## PRO-Z SERIES / PARTS

**Part Number**  
**Affected:** 618-05132 / 918-05132 Spindle Assembly

**Date:** April 17, 2017

**Subject:** 618-05132 / 918-05132 Mandatory Spindle Inspection

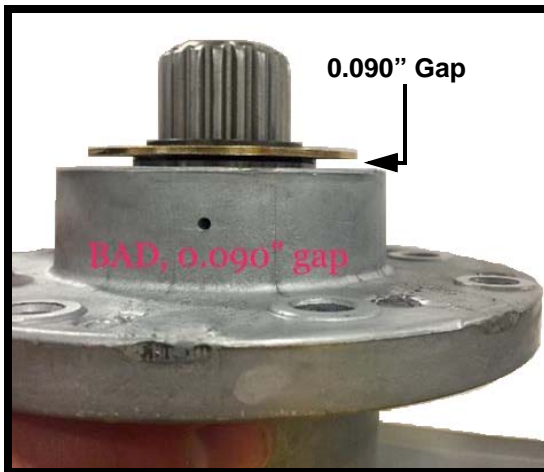
3. A bad spindle will have a 0.090" gap between the bottom of the dust cover and the top surface of the spindle housing and the bottom dust cover will protrude above the housing surface. See Figures 3 and 4.

**NOTE: When grasping the spindle shaft, there will be Noticeable Movement (end play) in and out of the spindle shaft on a BAD spindle.**

4. If a spindle is found to be bad (missing a race) order the required quantity of **918-05132** fabricated deck spindle assemblies from your parts source.
5. For Service Part inspection, submit a warranty claim for parts and labor time of **0.25 Hrs.** per spindle checked along with the quantity of bad spindles found in your dealer inventory. Use **918-05132** as the failed part number.
